PRODUCT CHANGE NOTICE

PCN # FFC2B20 B PCN
20161220

FFC2B20-XX-X

Footprint comparison as follows (height differences FFC2B20 2.00mm vs FFC2B10 1.20mm):

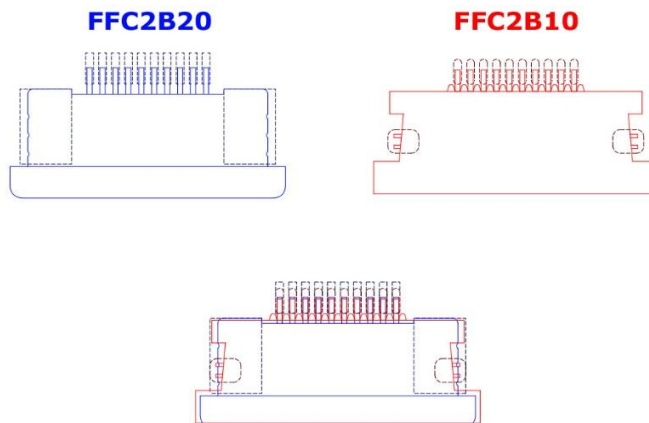
1. Made 'Not Suitable For New Designs'.
2. Remove Contact Numbers: 4, 5, 7, 9, 11, 13, 14, 15, 17, 18, 19, 21, 22, 23, 24, 25, 26, 27, 29, 30, 31, 34, 36, 37, 38, 39, 41, 45, 48, 54, 57, & 60.
3. Remove Gold Plating for all number of contacts.

Alternatives to achieve a given required number of contacts by using the FFC2B10.
